Product Change Notification: E-19-016902

RZ Relay

Description of Changes

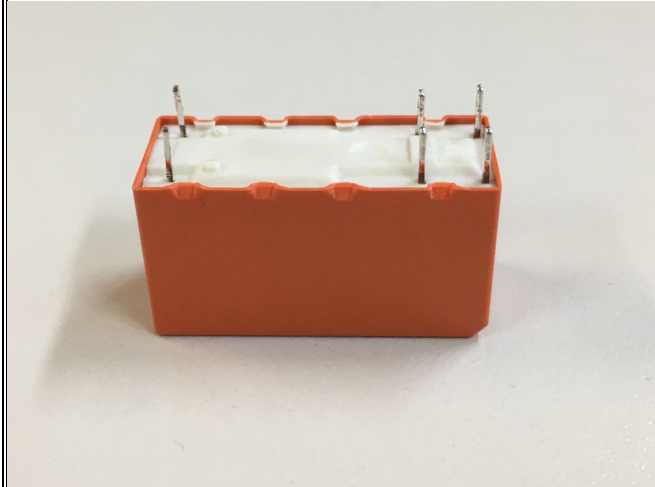
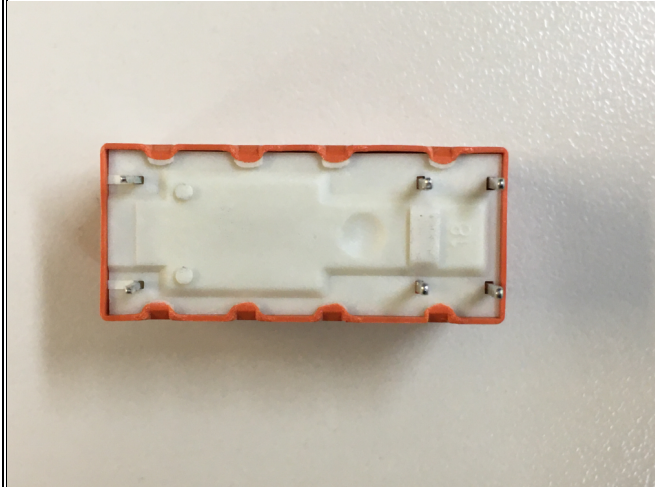
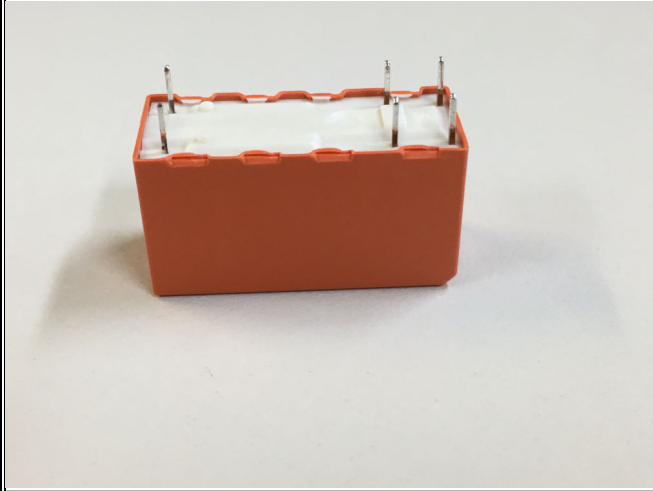
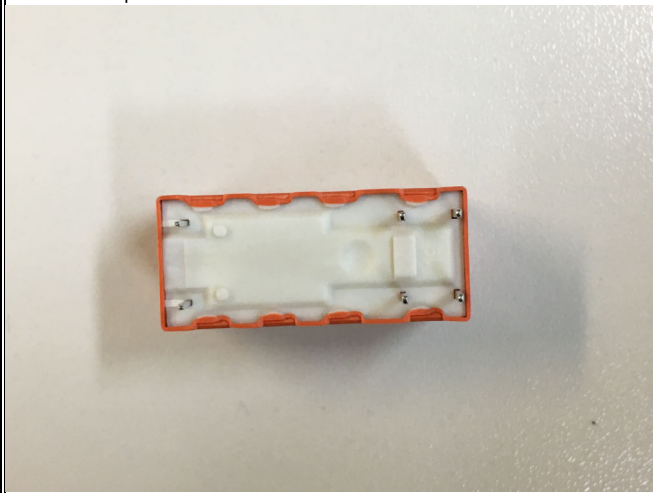
Cover fixing of RZ relays will be slightly changed by increasing the length of the case hot embossing (see picture below). This supports production process stabilization as well as fixation strength of the case on the relay base (this change is not valid for RZ reinforced flux proof versions, e.g. RZ Haz Loc, RZ socketable and RZ -R). Additionally TE is changing the datecode format at RZ relay from four digits YYWW (Year-Year-Week-Week) to six digits to improve the traceability of produced relays. New format will show YYWWDS (Year-Year-Week-Week-Day-Shift). Example given: 19452B means Year 2019, Calendar Week 45, Tuesday, 2nd shift of this day. For detailed information regarding the change please contact your sales representative or Field Application Engineer. All parameters and approved performance/ratings remain unchanged.

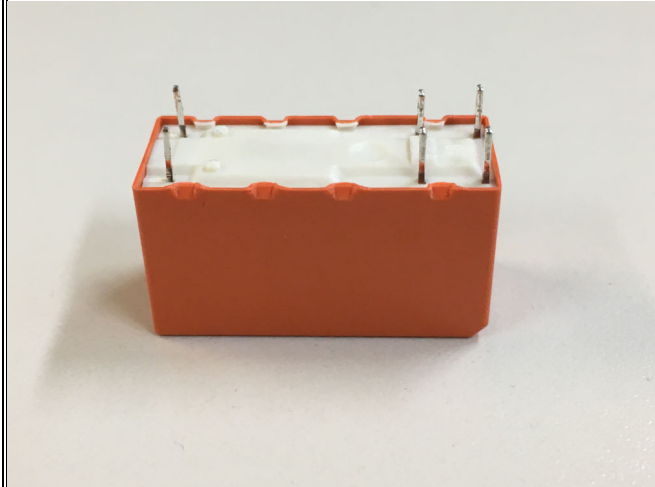
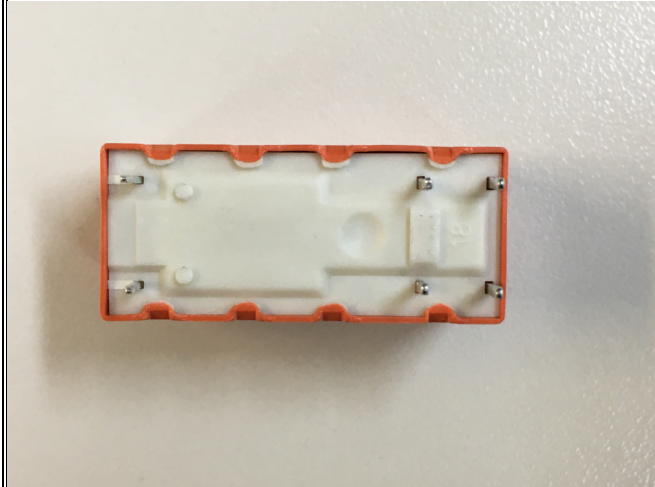
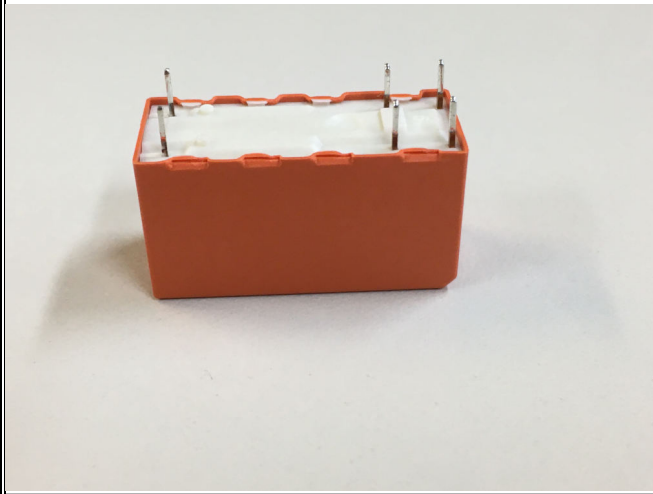
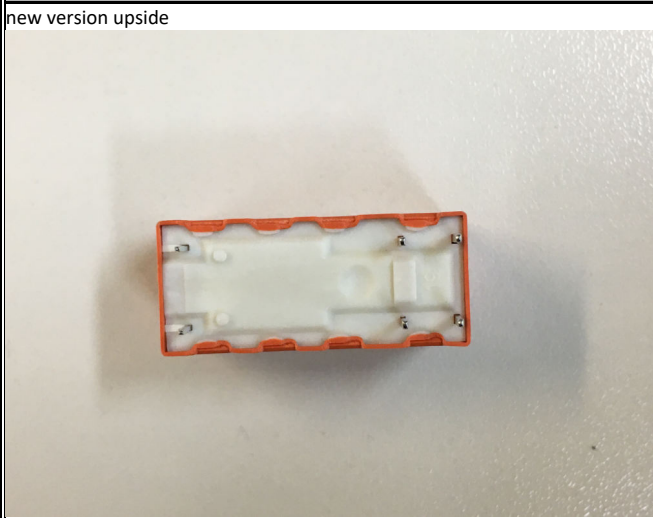
Cover fixing of RZ relays will be slightly changed by increasing the length of the case hot embossing (see picture below). This supports production process stabilization as well as fixation strength of the case on the relay base (this change is not valid for RZ reinforced flux proof versions, e.g. RZ Haz Loc, RZ socketable and RZ -R). Additionally TE is changing the datecode format at RZ relay from four digits YYWW (Year-Year-Week-Week) to six digits to improve the traceability of produced relays. New format will show YYWWDS (Year-Year-Week-Week-Day-Shift). Example given: 19452B means Year 2019, Calendar Week 45, Tuesday, 2nd shift of this day. For detailed information regarding the change please contact your sales representative or Field Application Engineer. All parameters and approved performance/ratings remain unchanged.
